LiDAR Quality Assurance (QA) Report
Cherokee County, South Carolina
February 13, 2009

Submitted to:
USGS
Prepared by:

Dewberry
Fairfax, VA

Reference: USGS Contract 07CRCN0004, Task Order 07004C0009, South Carolina 16 County LiDAR, dated January 17, 2008.

***Figure 13** – 8118-02 Building artifact. (Left: Ground model colored by elevation, Right: Full point cloud intensity model).*

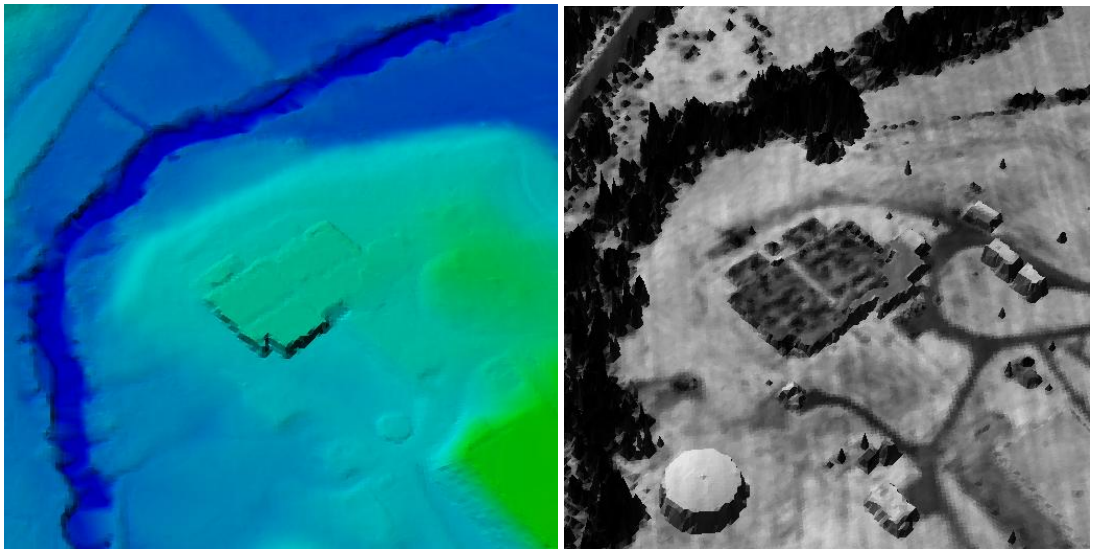
It is not uncommon for the classification algorithms to occasionally misclassify non-ground points. This misclassification results in remnants of vegetation or manmade structures known as artifacts that do not represent the bare-earth terrain. Figure 13 shows an example of an area where building points were left in during the classification process. This error is very common in production datasets, but it is easy to fix and does not alter the usability of the LiDAR product.

Figure 14 *– 8107-01 Inconsistent editing (L: Ground density model, R: Full point cloud intensity Model).*

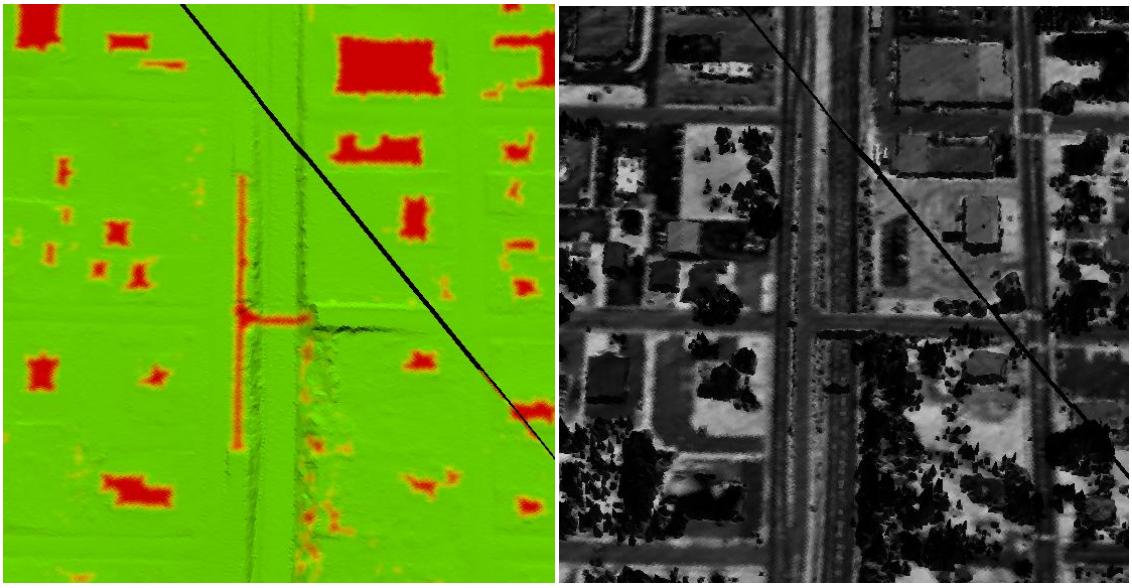
Several instances of inconsistent editing of natural features were found in this dataset. In the case illustrated in Figure 14 it appears as though an overpass has been correctly removed however the classification method was a bit too aggressive and part of the road was removed on the other side. This type of error was not found to be very common in the dataset and has minimal impact on the quality of the data.

Figure 15 *- 7250-01 Misclassification of ground points. Left image is ground density model and middle is full point cloud with intensity. Right image is full point cloud colored by classification, yellow is unclassified (class 1), purple is ground (class 2), and blue is water (class 9).*

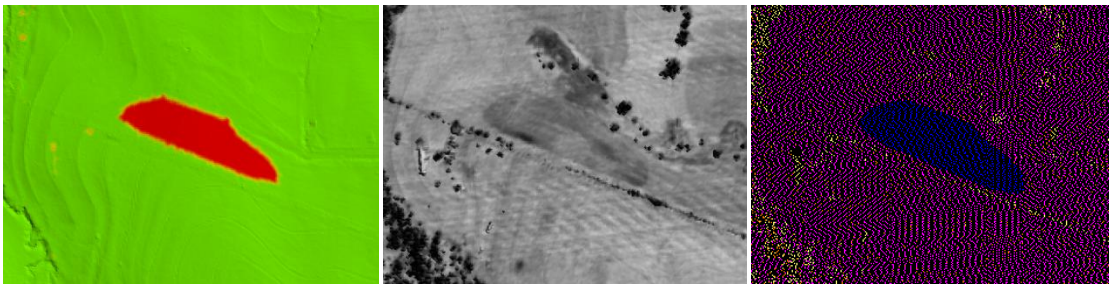
One of the more common problems seen in Cherokee County was misclassification of ground points as water. During the classification process, it appears that hydro-lines were used to classify water points. At the time of acquisition however, many of these retention areas were partially dry and the LiDAR sensor was able to return ground points resulting in a good representation of the ground surface in these areas. In the left image of Figure 15, the red area signifies an absence of ground points in a water retention area. The full point cloud intensity image in the middle shows that the LiDAR sensor actually returned points as there was no water present at the time. The image on the right illustrates that these points were classified as water.

Figure 16 *- 7261-03 Misclassification of ground points. Left image is ground density model and middle is full point cloud with intensity. Right image is full point cloud colored by classification, yellow is unclassified (class 1), purple is ground (class 2), and blue is water (class 9).*

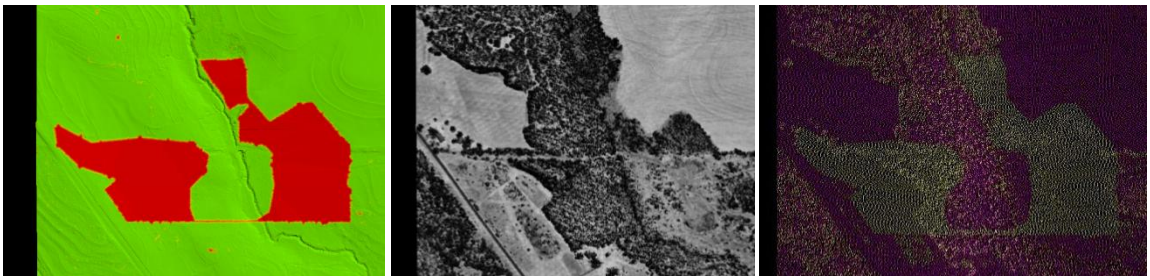
A second type of misclassification found in Cherokee County appears to be more editor error than systematic error. Figure 16 displays a large area of points that seem to have been accidentally placed into class 1 (unclassified). The abrupt changes in vegetation type and density (as seen in the middle image of Figure 16) may have influenced this error during the classification process. This type of misclassification was found a few times in the dataset and can be easily fixed.

Figure 17 *– 7191-02 Poor LiDAR penetration in vegetated area. (L: Ground density model, R: Full point cloud intensity).*

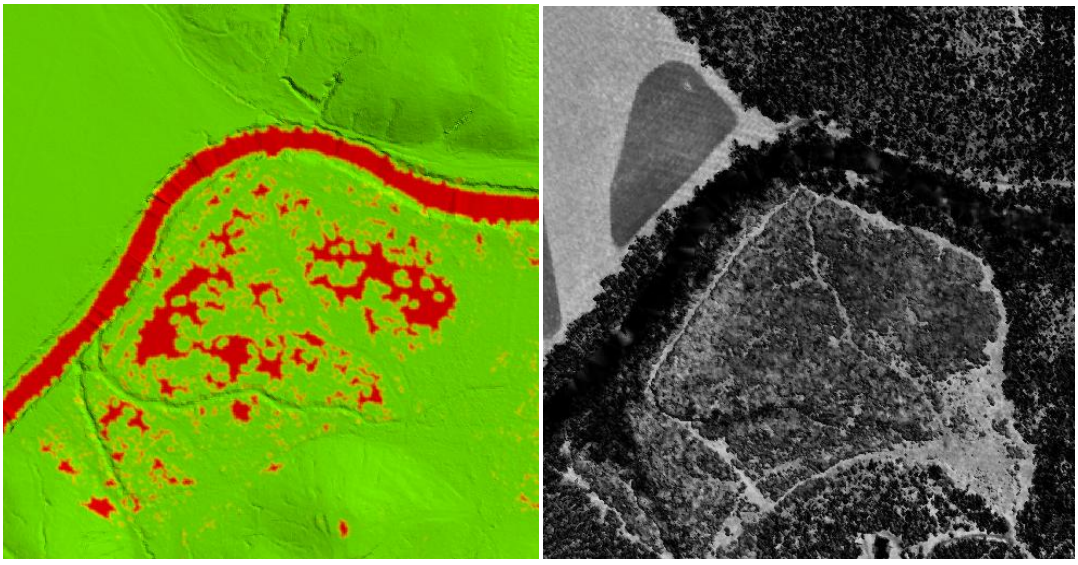
Several areas were identified with patches of low density of ground points. This may be unavoidable. When the vegetation is very dense, the LiDAR may not penetrate the canopy all the way to the ground; this is illustrated in Figure 17. This type of sparse density of ground points was found throughout the dataset and causes the surface to be sometimes less accurate. Poor LiDAR penetration cannot be fixed without a re-flight, but even then, this might be inherent to the type of vegetation surveyed. While increasing the flight line overlap would provide different angles of incidence and would increase the chance of penetrating the canopy, this is more expensive, and it is possible that the density of the vegetation prevents any point to reach the ground. Regardless, the accuracy of the data is always expected to diminish in vegetated area, and when a few ground points are available an elevation model can be interpolated with acceptable precision especially in flat terrain.

Figure 18 *– Tile 8108-01: full point cloud colored by class, black areas are roads without any return.*

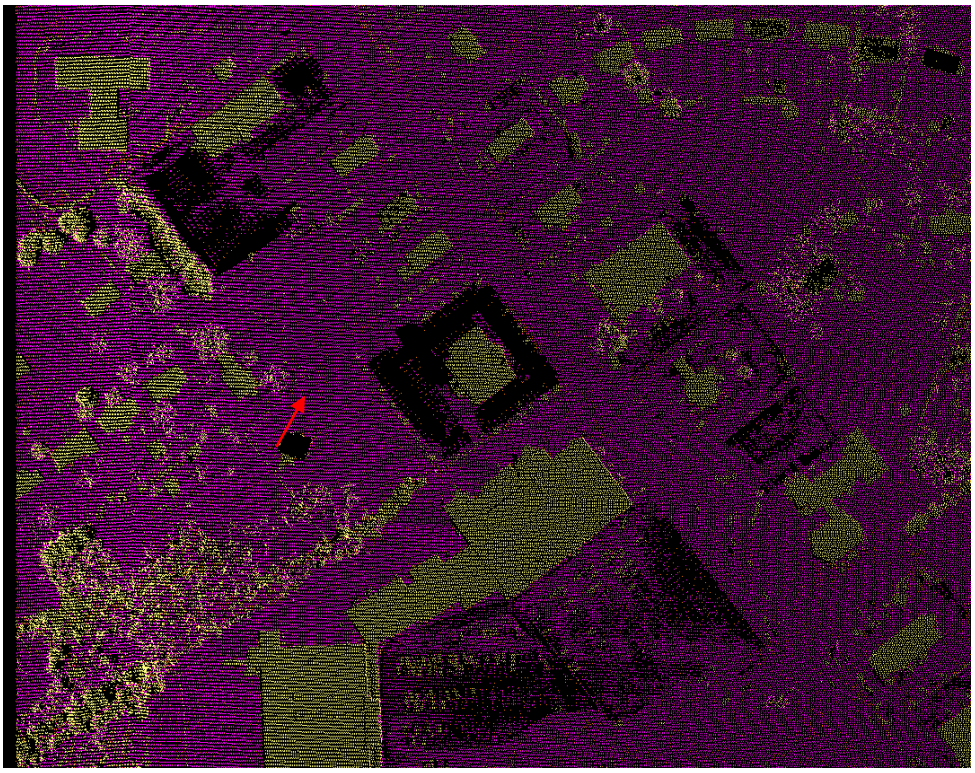
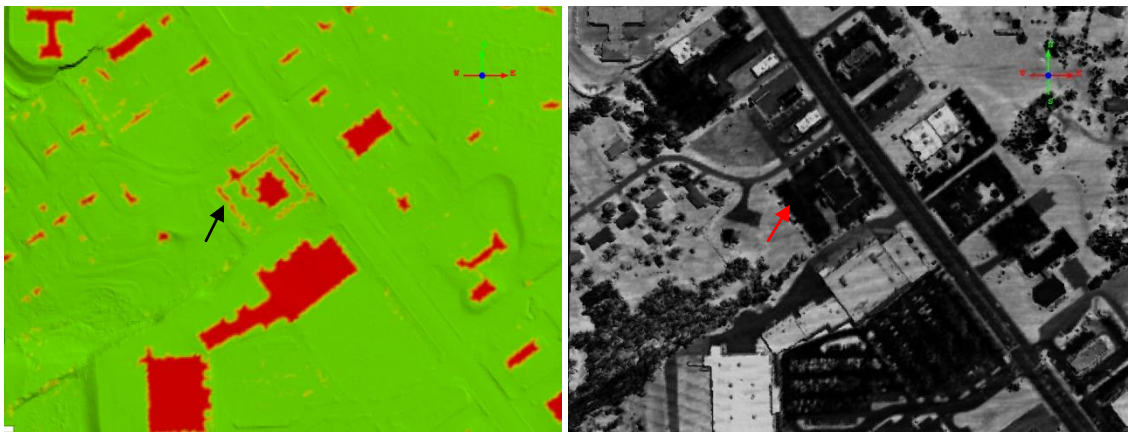
Another anomaly detected in the data is the lack of returns on certain type of roads, buildings, runways, and parking lots, as depicted in Figure 18.

Several possible explanations for this anomaly are low gain setting or low emission power, both resulting in a non detection of a weak reflected signal. A weak reflected signal can occur on certain types of asphalt that absorb the near infrared wavelength. For the roads and buildings there is no simple fix possible except a re-flight without a guarantee of success.

The data user should be aware that this issue has almost no impact on the ground integrity: buildings are removed regardless and roads edges are present allowing a proper definition of the terrain. Moreover, this kind of acquisition "drop-off" had a limited occurrence.
